**PLANNING APPROVAL,  
PLANNED UNIT DEVELOPMENT &  
SUBDIVISION STAFF REPORT**

**Date: June 5, 2008**

<b><u>NAME</u></b>	Elijah House Subdivision
<b><u>SUBDIVISION NAME</u></b>	Elijah House Subdivision
<b><u>LOCATION</u></b>	1867 Duval Street (South side of Duval Street, at the South terminus of Murray Hill Court [private street])
<b><u>CITY COUNCIL DISTRICT</u></b>	District 3
<b><u>PRESENT ZONING</u></b>	B-3, Community Business District
<b><u>AREA OF PROPERTY</u></b>	1 lot / 0.5 acres $\pm$
<b><u>CONTEMPLATED USE</u></b>	Planning Approval to allow an outreach program with housing to include prison release inmates in a B-3, Community Business District, Planned Unit Development Approval to allow multiple buildings on a single building site, and Subdivision approval to create one legal lot.
<b><u>TIME SCHEDULE FOR DEVELOPMENT</u></b>	Immediate
<b><u>ENGINEERING COMMENTS</u></b>	Must comply with all storm water and flood control ordinances. Cannot concentrate storm water runoff to an adjacent property without a release agreement or a private drainage easement. Must provide detention for any impervious area added since 1984 in excess of 4,000 square feet. Any work performed in the ri

# SITE PLAN

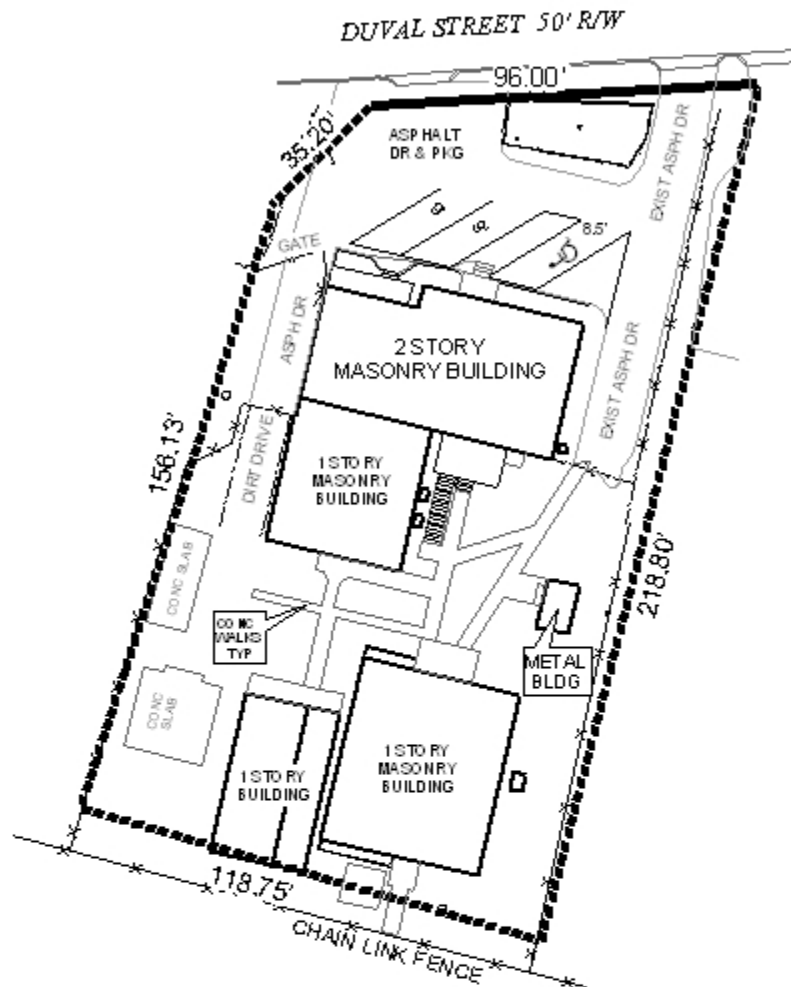
No dumpster is depicted on the site plan. If a dumpster is used, it must be depicted on the site plan, or a statement must be placed on the site plan indicating that no dumpster is used.

The 25-foot minimum building setback line is not depicted on the plat or site plans. The plat and site plans should be revised to depict the 25-foot minimum building setback line from Duval Street, adjusted for any required right-of-way dedication.

- 1) Revision of the site plan to reflect dedication of right-of-way along Duval Street, per the Subdivision conditions;
- 2) Revision of the site plan to depict paved parking as adjusted to accommodate the right-of-way dedication;

- 4) Revision of the tree and landscape plan for the site to accommodate the right-of-way dedication, and to depict all trees claimed for credit;
- 5) Revision of the site plan to depict an 8-foot high wooden privacy fence along the rear property line of the site;

- 6) Depiction of concrete wheel stops to ensure that vehicles will not encroach upon any required landscape areas;
- 7) Depiction of the 25-foot minimum building setback line, adjusted for the required right-of-way dedication; and

- 1) *A revised site plan was not provided depicted dedication, revised parking, compliance with tree and landscaping requirements, and other site improvements, as requested; and*
- 2) *No additional information was provided regarding the operation of the facility as it relates to identifying residents / outreach program beneficiaries.*

- 1) *A revised site plan was not provided depicted dedication, revised parking, compliance with tree and landscaping requirements, and other site improvements, as requested.*
